DEVELOPMENT REVIEW COMMITTEE (DRC) COMMENT REPORT

PROJECT NAME: 42 Hotel

CASE NUMBER: UDP-S23035

REQUEST: Site Plan Level IV Review: 75-Room Hotel with 984 Square Feet of Ancillary Bar, Dimensional Modifications to Tower Stepback, Tower Separation, and Increase in Floor Area Ratio (FAR), and Request to Pay the Central Beach Parking Facility Fee in Lieu of Parking in the Central Beach Regional Activity Center

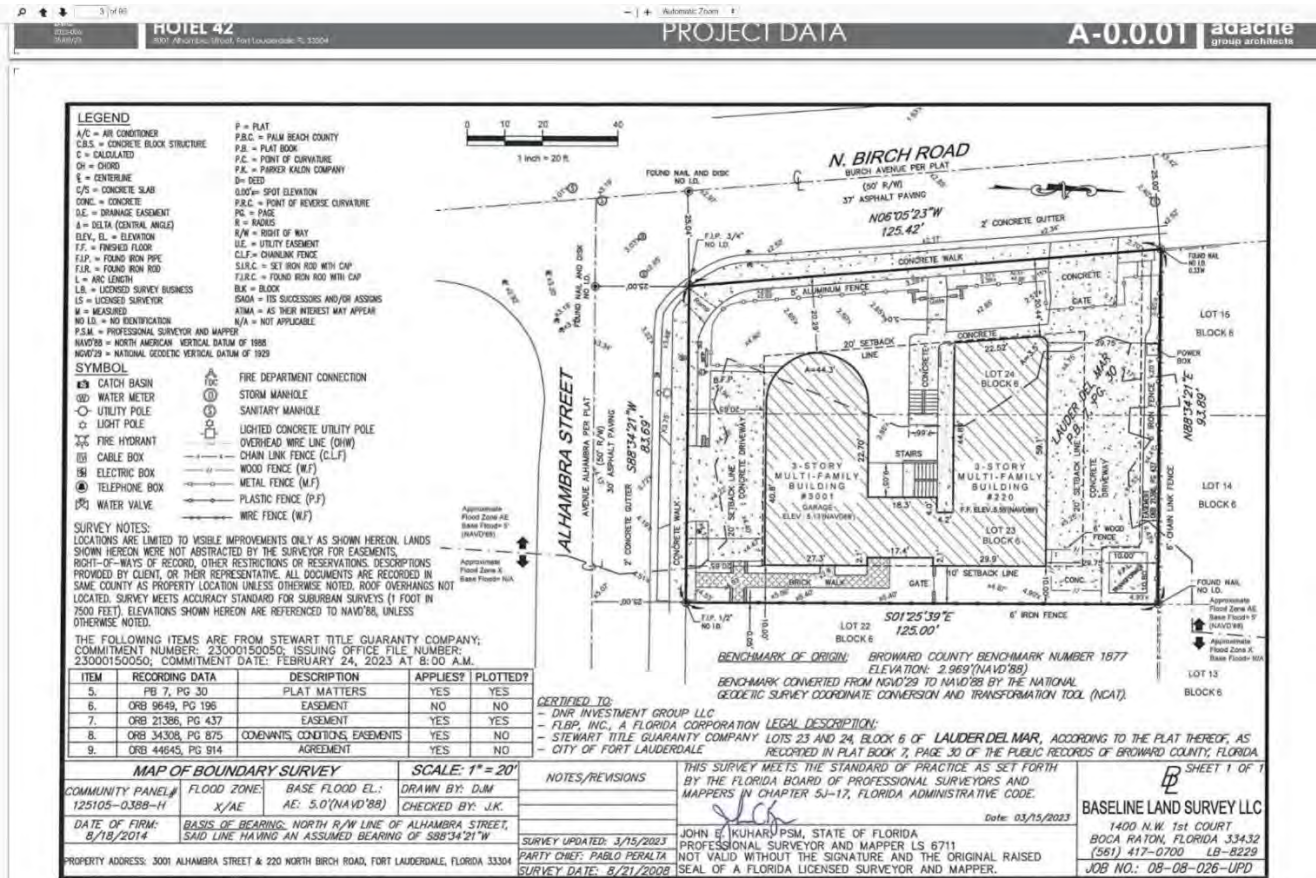
1. Provide the following flood zone data on the site plan from the (2014 FIRM Flood Insurance Rate Maps) 12011C0388H, X500, and "AE" flood zone with a base flood elevation of 5' NAVD 88.

The preliminary maps show a BFE of 6 ft. NAVD (flood zone "AE").
 See attachment of the Preliminary Flood Map

Preliminary flood map BFE

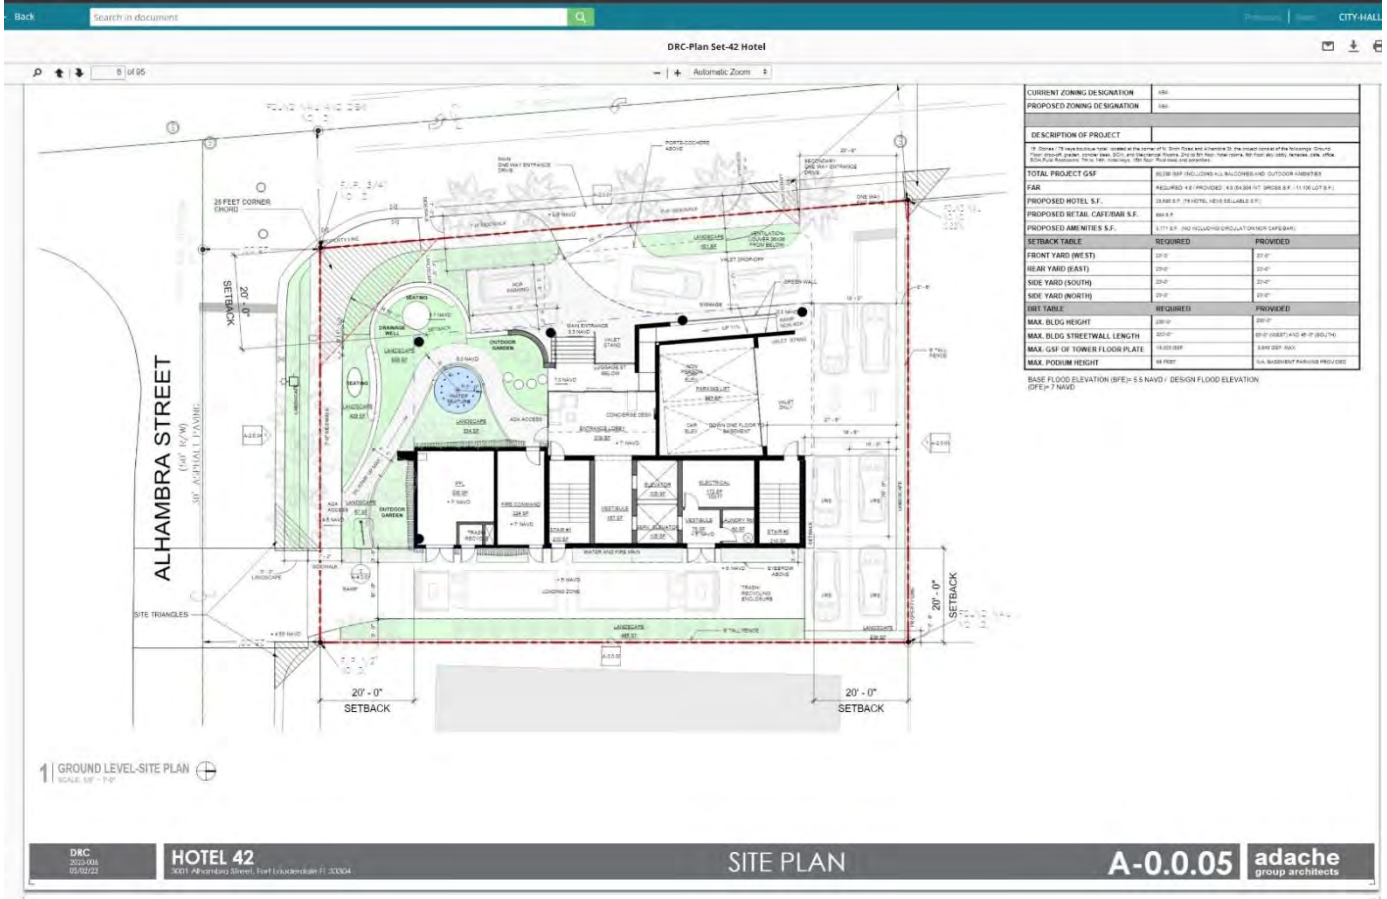
The BFE using the Preliminary Maps is BFE 6 ft. + 1' freeboard = 7 ft. NAVD 88 FFE

See attachment of (site plan A 0 0.05) please show that the Finish floor elevation will meet the BFE of 6 ft. + 1 ft.=7' NAVD 88 once the preliminary maps go into use this will be the flood maps in use.

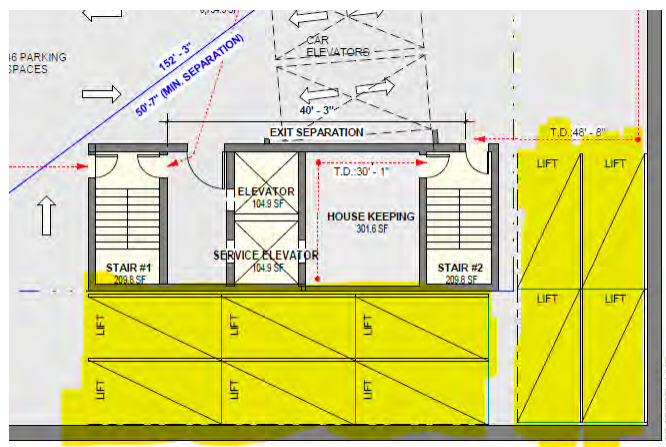
Please provide specific details of solid waste and recycling collection per building
